# Access Compliance Report

## Public Rights-of-Way

| Intersection ID: 9172                   | Main Street: E_CRAIGHEAD_RD | Cross Street: N_TRYON_ST                | Location: SW           |
| ADA ID: 5C8A2C9136FF                    | Ramp Type: Perp             | Initial Pass/Fail: Fail                 | Overall Compliance: No |

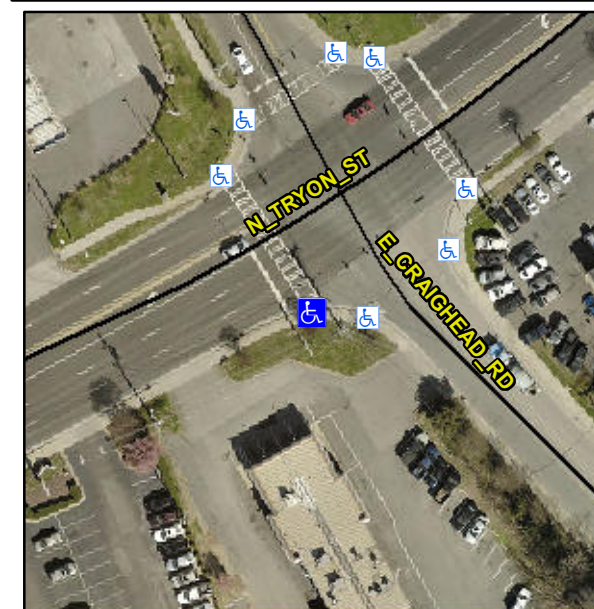
**Not Found, R304.5.1, R304.2.2, R304.5.3**

| Compliance | Description           | Data  | Compliance | Description                 | Data |
|------------|-----------------------|-------|------------|-----------------------------|------|
| N/A        | Ramp Length (in)      | 72.0  | No         | Ramp Slope (%)              | 8.5  |
| No         | Ramp Width (in)       | 44.0  | No         | Ramp XSlope (%)             | 2.3  |

**Remove & Replace Entire Ramp.**
